CARROLL MUNICIPAL WATER SUPPLY

Permit 2020-0493, Supplement 01

RE: Carroll, Iowa
Water Distribution Main Replacement - 2020
JEO Project No. 191586.00

Enclosed are two work change directives instructing the contractor to install ductile iron water main within railroad right of way at 6' bury by directional drill methods and allowing the contractor to use directional drill methods for installation of the remainder of the water main.

PLAN AND PROFILE D.01

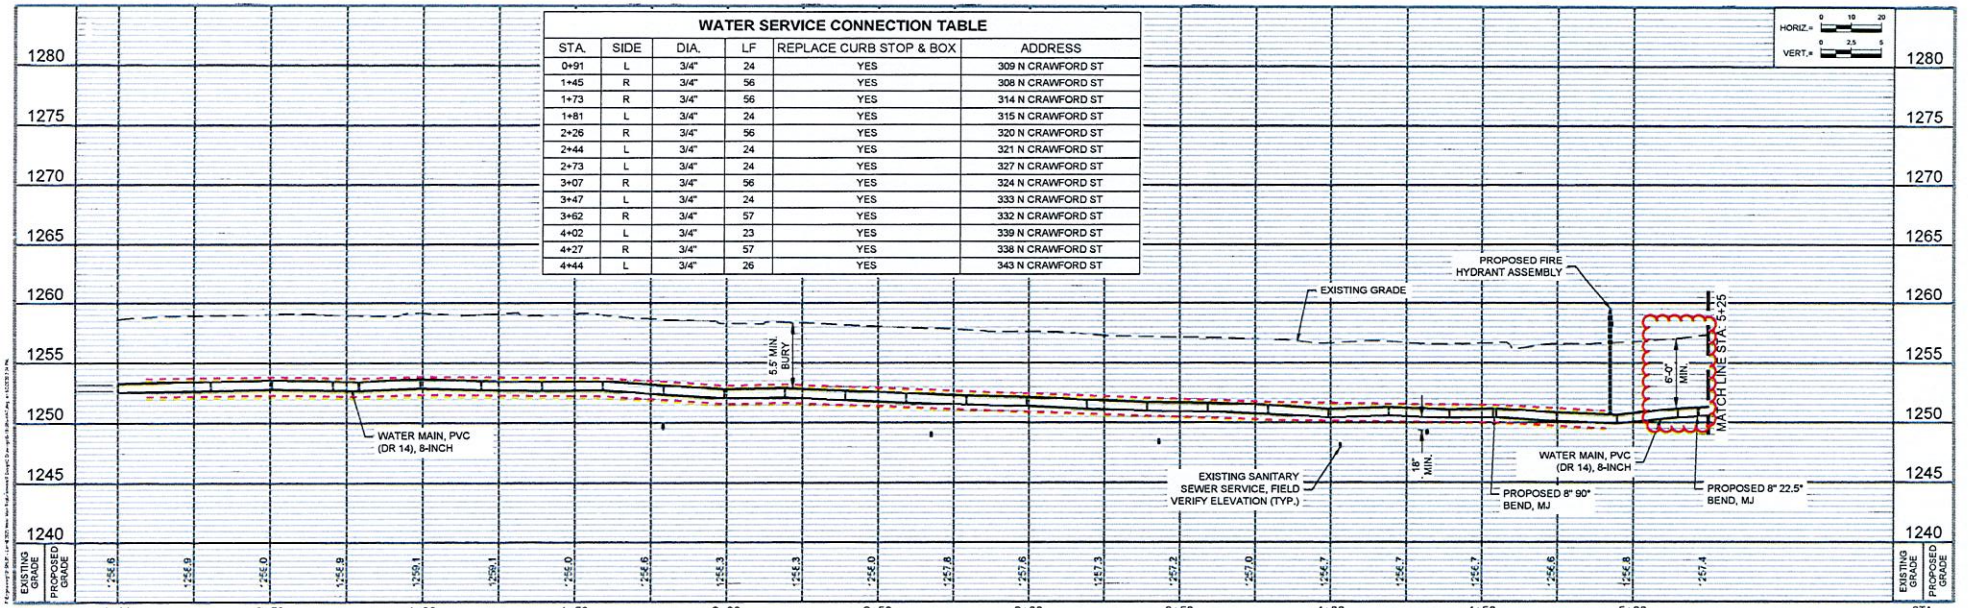
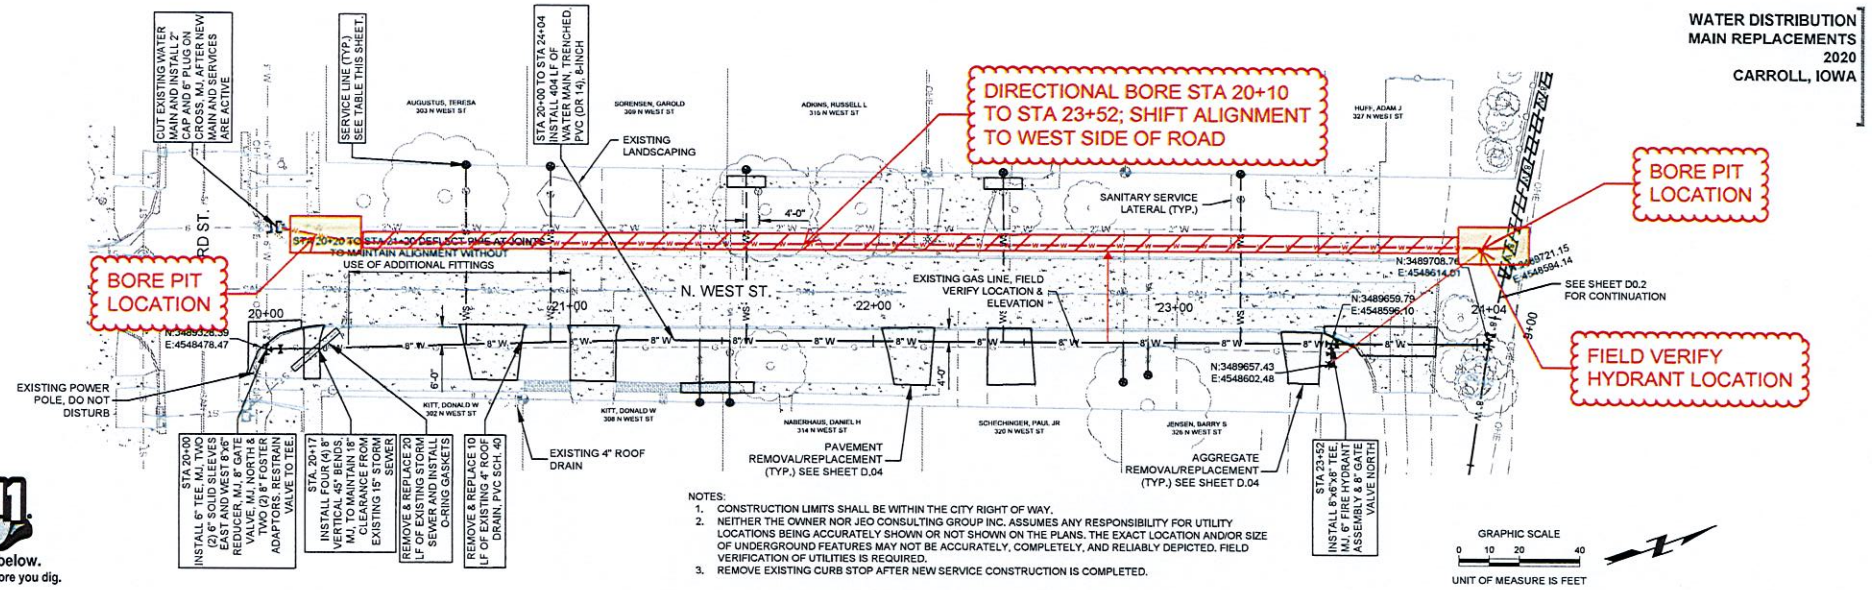
You are directed to proceed promptly with the following change(s):
Description Install water main by directional bore as shown on the attached plan sheets.
Purpose of Change Directive Contractor's proposal, decrease impact to adjacent property owners.
Attachment(s) Revised sheets D.01, D.04, D.05, D.06, D.07, D.08; Changes to the work; Contract Price Change Estimate

1. The contractor is to bore the alignments as shown on the attached plan sheets.
2. Measurement for the work will be by the linear foot and will not include locations installed by open cut.

PLAN AND PROFILE D.01

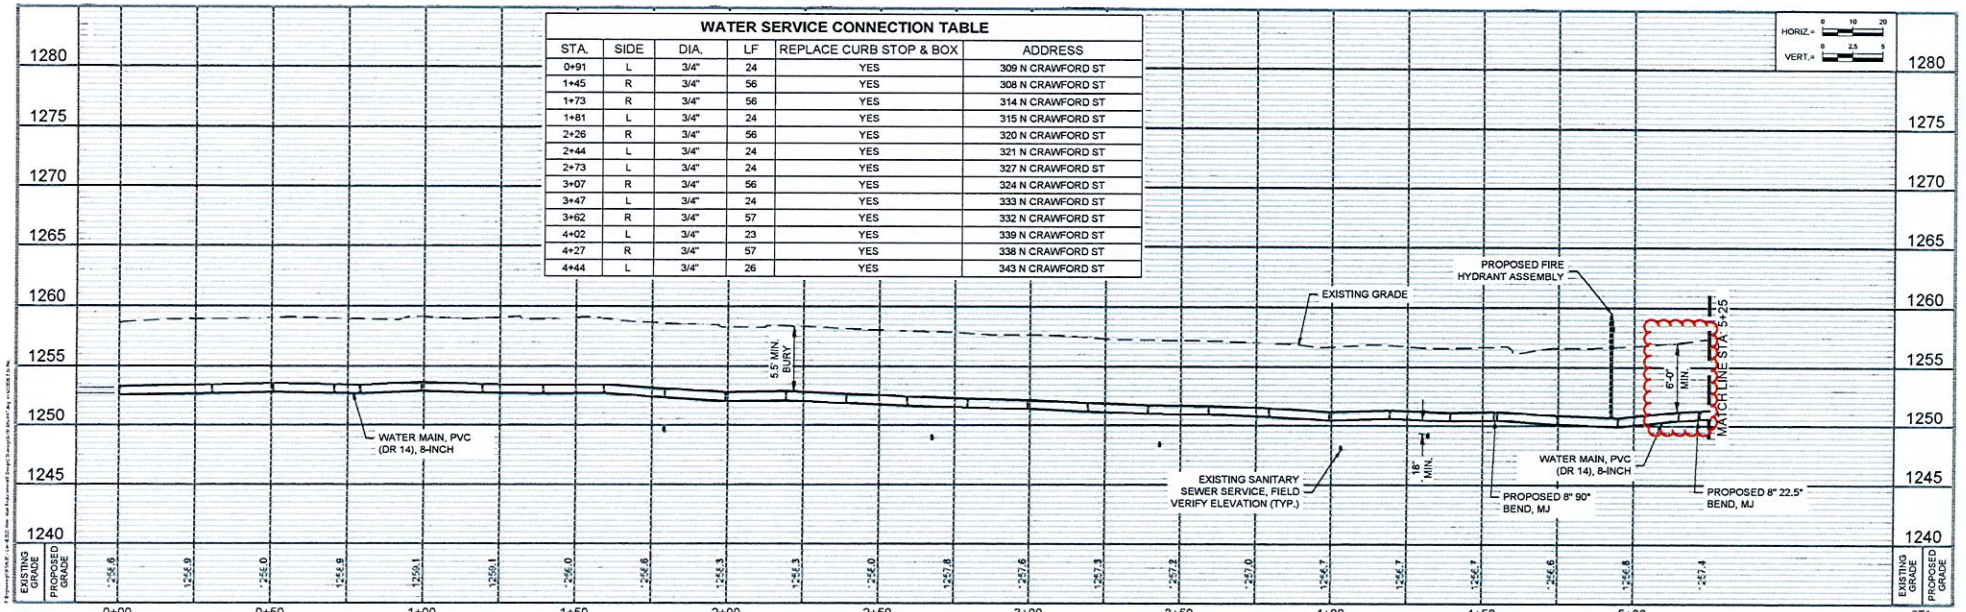
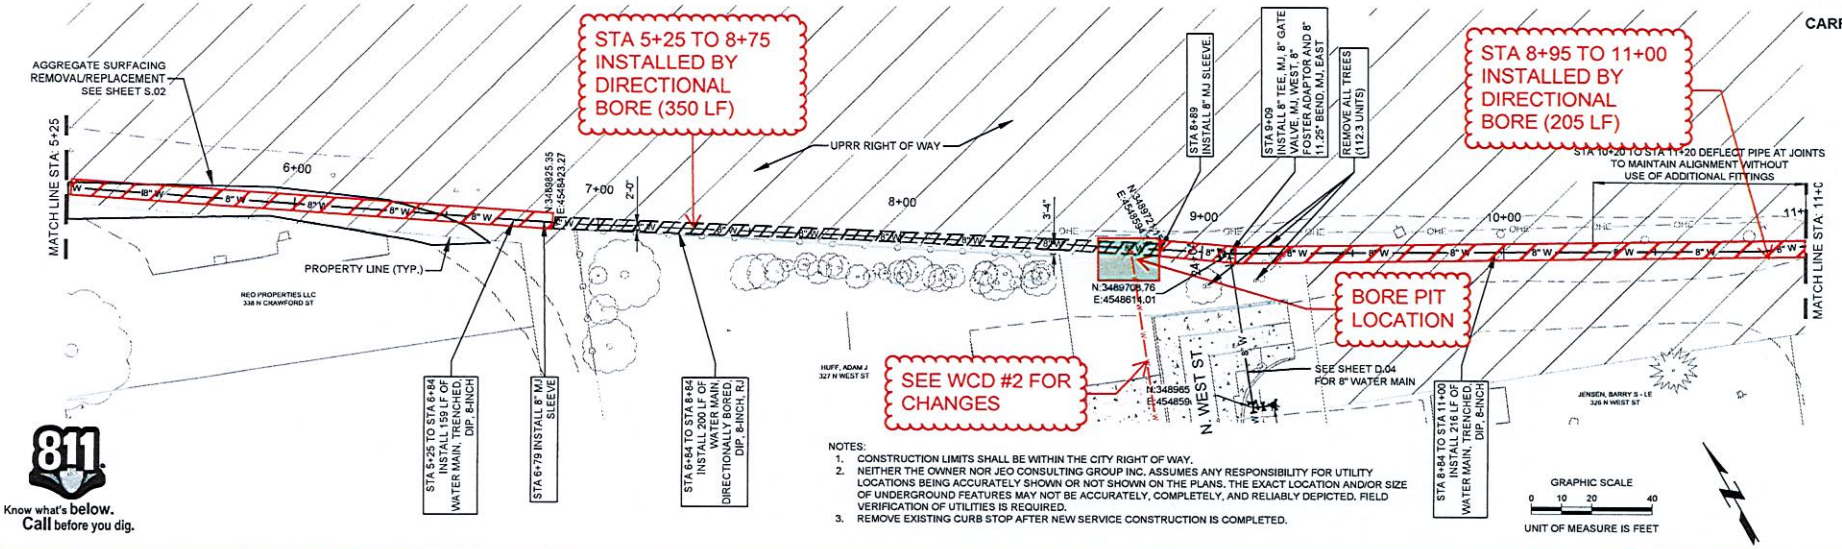
You are directed to proceed promptly with the following change(s):
Description Install 8" ductile iron pipe by directional bore at 6 foot bury along UPRR right of way with approximate excavation and bore pit locations shown on the attached plan sheets.
Purpose of Change Directive Compliance with UPRR Permit conditions.
Attachment(s) Revised sheets C.01, D.01 to D.03; Changes to the work; Contract Price Change Estimate

1. The alignment along UPRR railroad right of way is to be 8" ductile iron pipe, directionally bored at 6-foot depth. Contractor to verify bore pit location and dimensions on the provided plan sheets.
2. Contractor shall conduct work in a manner to minimize duration of work on UPRR right of way, including boring pit locations and boring operations.
3. Bid Item 44 – "WATER MAIN, TRENCHED, DIP (CL52), 8-INCH" is established as a part of the contract. prices, quantities, and estimate reference information shall be as shown on the figures and pricing change sheet.
4. Bid Item 45 – "WATER MAIN, TRENCHLESS, DIP, RESTRAINED JOINT (CL52), 8-INCH" is established as a part of the contract. prices, quantities, and estimate reference information shall be as shown on the figures and pricing change sheet.
